RESPONSES TO JULY 9, 1984 DNR COMMENTS ON THE NOISE REPORTS

EXXON MINERALS COMPANY
CRANDON PROJECT

OCTOBER 31, 1984

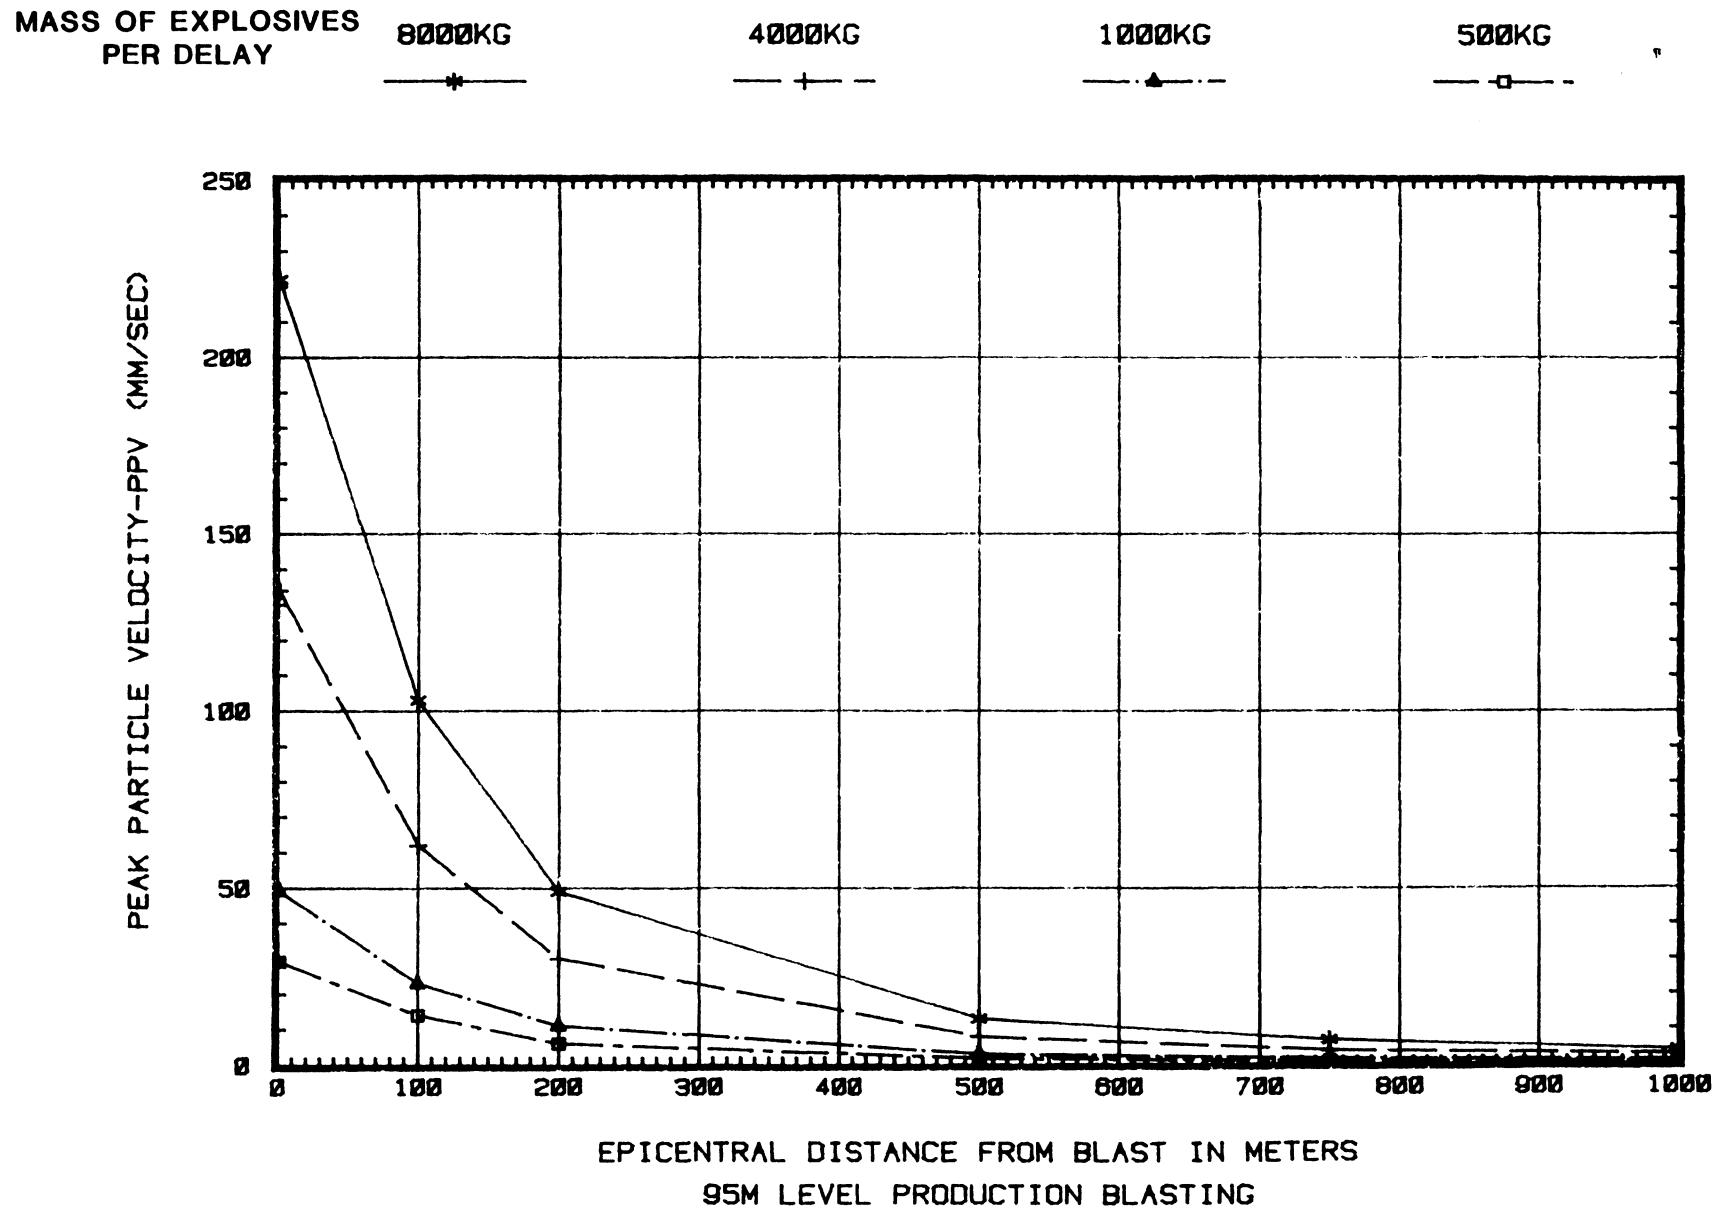
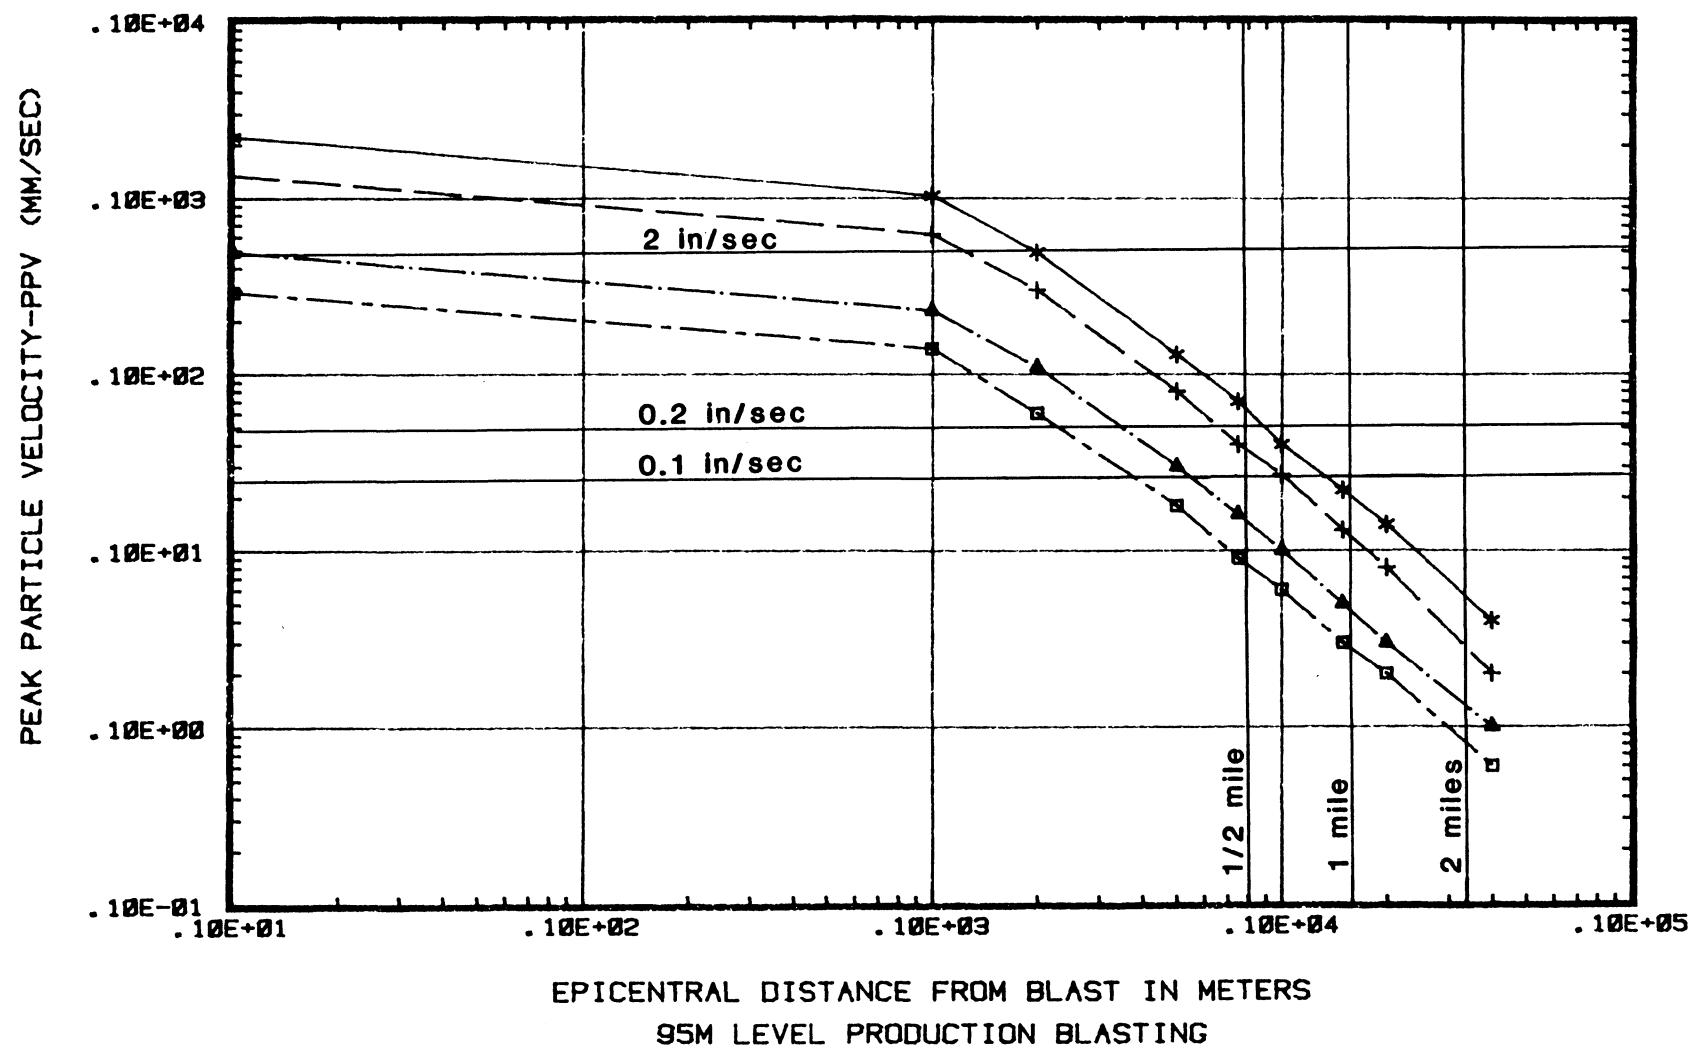
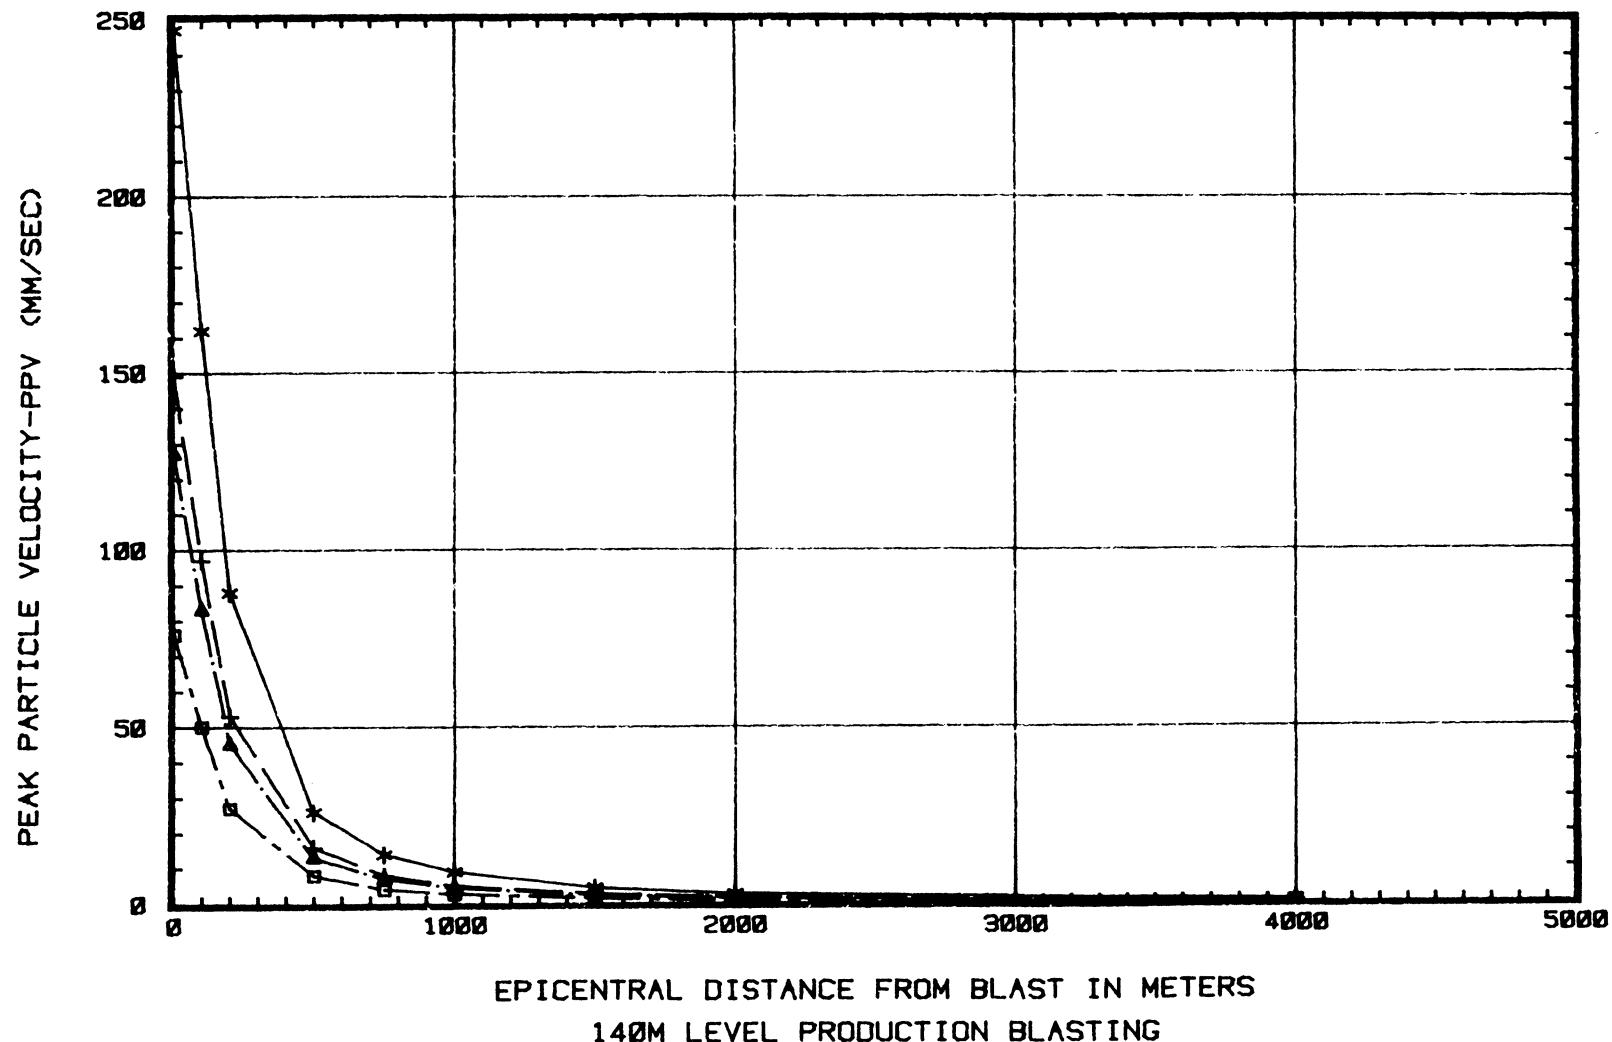
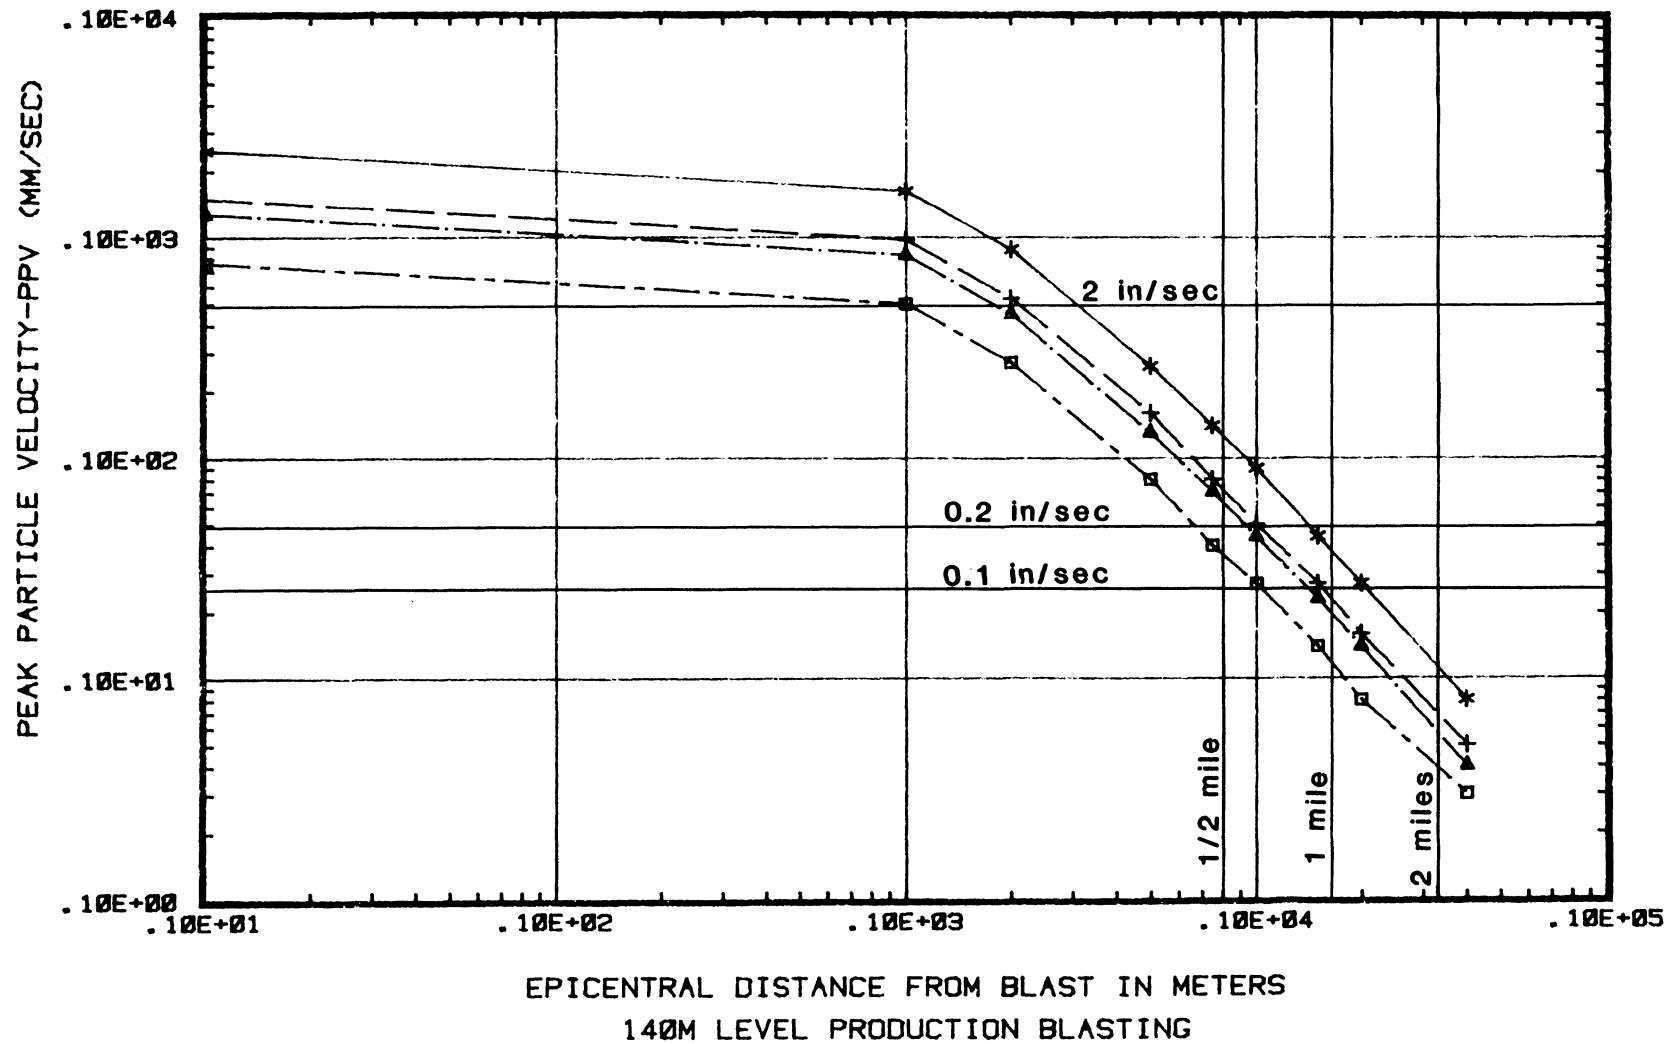
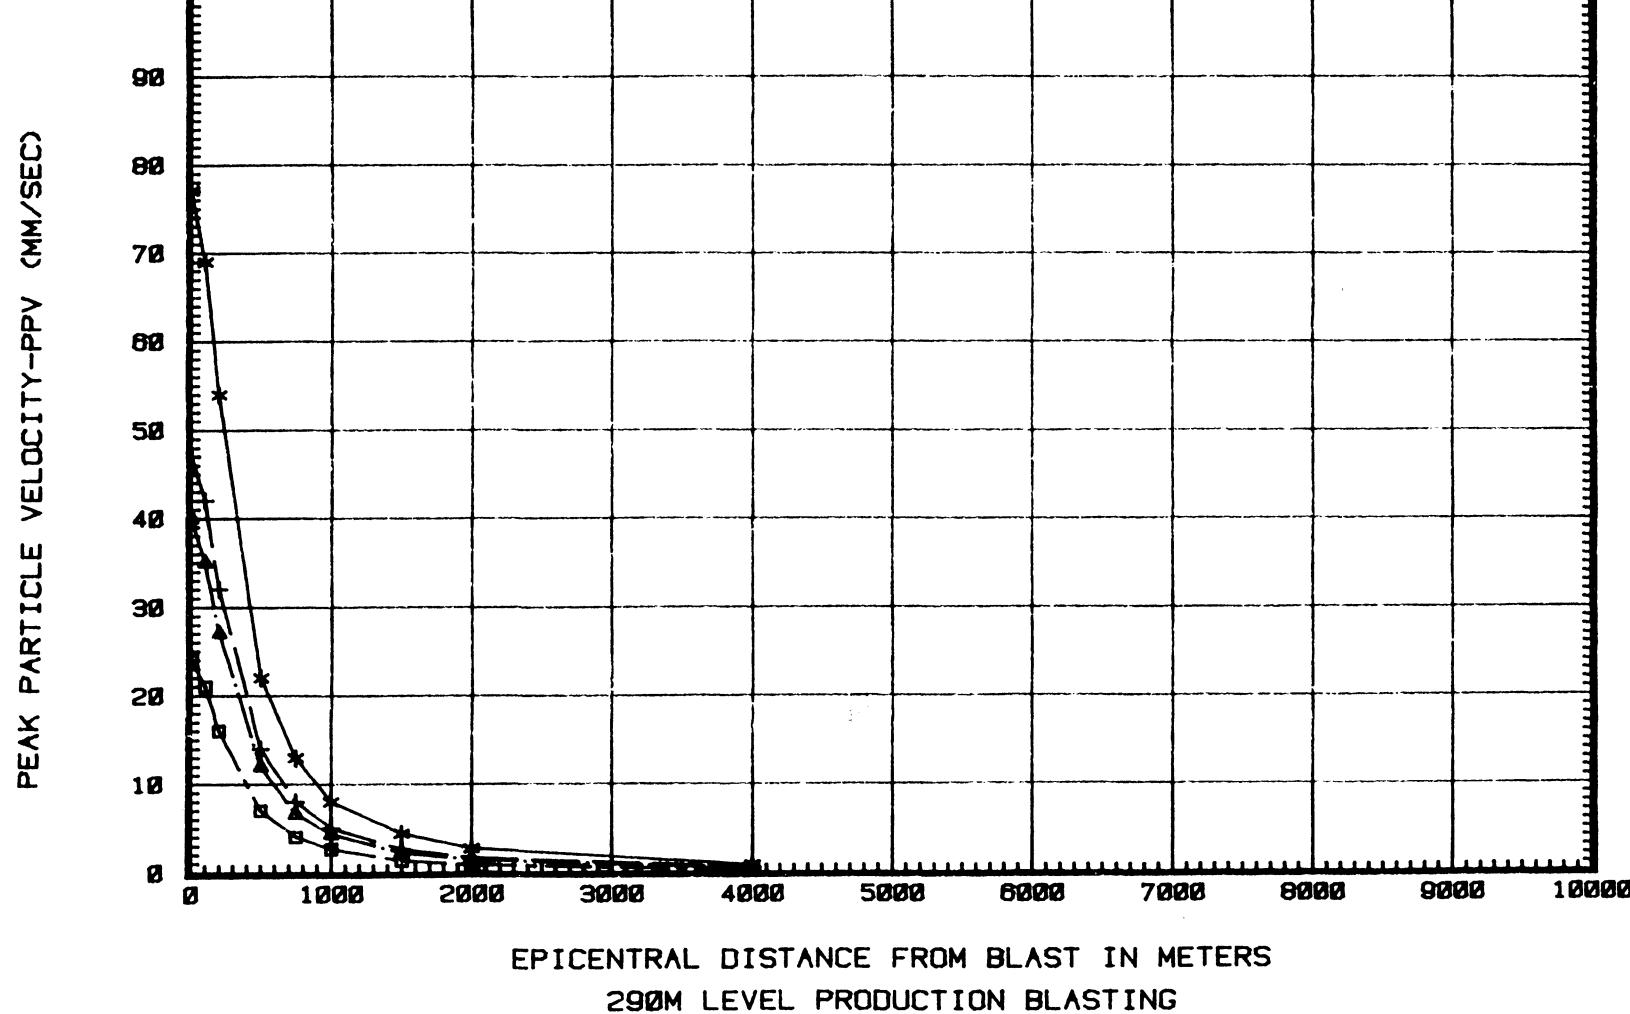
The analysis method is depicted on p. 61 of the October 31, 1984 responses. While the method is correct, its application is not. It is assumed that blast vibrations will travel in a straight line from the point of explosion to the ground level receptor. In fact, vibrations move a greater distance through the bedrock before traveling through the overburden. This causes surface vibrations to be greater than predicted using Exxon's approach. Since off-site vibrations were shown to be detectable, the analysis should be adjusted to account for this phenomenon. This subject is discussed further in "Vibrations of Soils and Foundations" by Ricardi.

The estimated ground surface peak particle velocities presented on Figures 2 through 9 in the response to comment No. 2 cover a wide range of cases for both blast depth and delay charge weight. Actual mine development or production blast design during operations will be such that the safety of mine surface facilities will be insured. With this in mind, blast design will limit PPV directly over the mine site to less than 50.8 mm/s (2.0 inches/second). As indicated on Figures 2 through 9, the calculated site responses for some of the delay sizes evaluated would result in PPV in excess of the imposed limit of 50.8 mm/s (2.0 inches/second). For the conditions assumed in predicting site response, higher delay charge weights would be unacceptable and not used for an underground blast.

Using the 50.8 mm/s (2.0 inches/second) as a limiting threshold, blast designs producing PPVs directly above the blast exceeding this threshold are meaningless. For acceptably designed blasts/delay, using the 50.8 mm/s (2.0 inches/second) design criteria, PPVs at a radius of 805 m (0.5 mile) or greater are generally less than 5.1 mm/s (0.2 inches/second) (Figures 2 through 9) or in the range defined on attached Figure 1 as between detectable and barely detectable. At a distance of 1,610 m (1 mile), predicted PPVs are below the barely detectable level of 2.5 mm/s (0.1 inches/second).

Curves have been replotted showing recalculated PPVs on both linear and log-log formats (see Figures 2 through 9 in the response to comment No. 2).
